<b>Subject:</b>  SQUEAKING/GRINDING NOISE FROM REAR BRAKE	<b>Bulletin No:</b> 04-001/16
	<b>Last Issued:</b> 01/14/2016

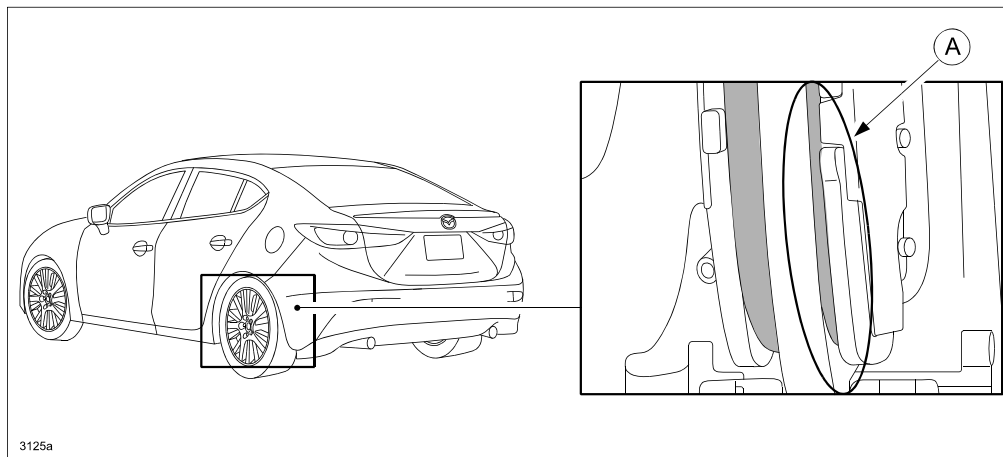
Some vehicles may experience a squeaking/grinding noise from the rear brake even after the brake pedal is released. Upon inspection, the caliper mounting support is corroded and one of the disc pad is abnormally worn out (A). This is caused by vehicle usage in an area using road salt. The surface of the mounting support may swell from corrosion causing premature disc pad wear and brake noise.

To correct the problem, an improved caliper mounting support has been newly established as a service part. The anti-corrosion surface treatment has been changed from Zn to Zn-Ni plating.

## REPAIR PROCEDURE

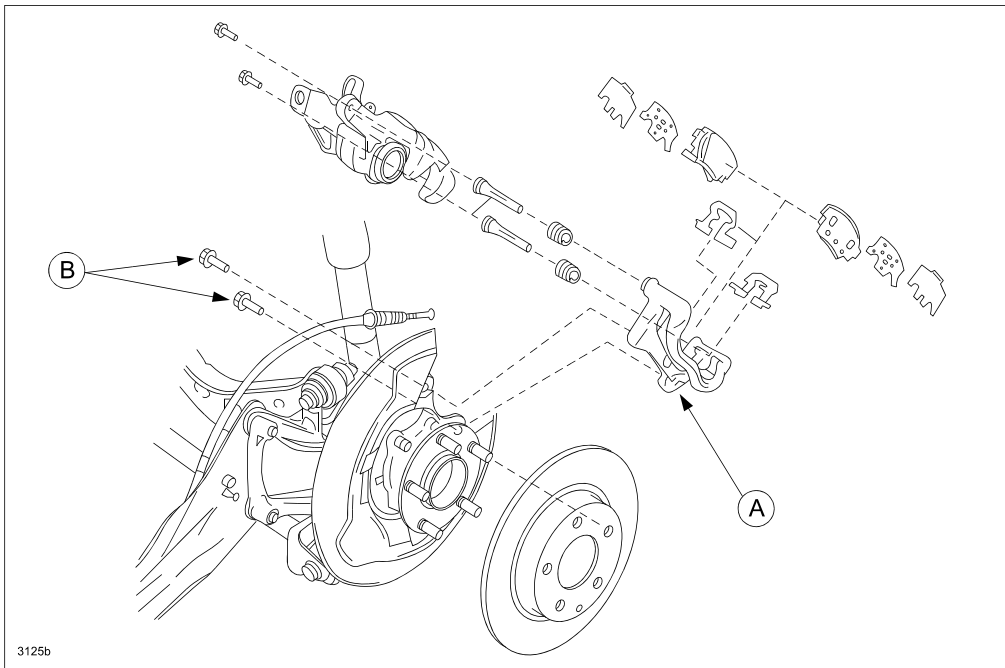
1. Verify that the caliper mounting support(s) is corroded and the disc pad(s) is abnormally worn out.
2. Replace the caliper mounting supports (both sides) with the modified service parts sets and attachments with new parts according to the instructions on MS3 online or the Workshop Manual (section 04-11 REAR BRAKE (DISC) REMOVAL/INSTALLATION).

**CAUTION:** When installing the modified mounting support (A), tighten the installation bolts (B) with the upper limit of the tightening torque specified in the Workshop Manual (6.6 Nm, 48 ft-lbf, 6.7 kgfm).
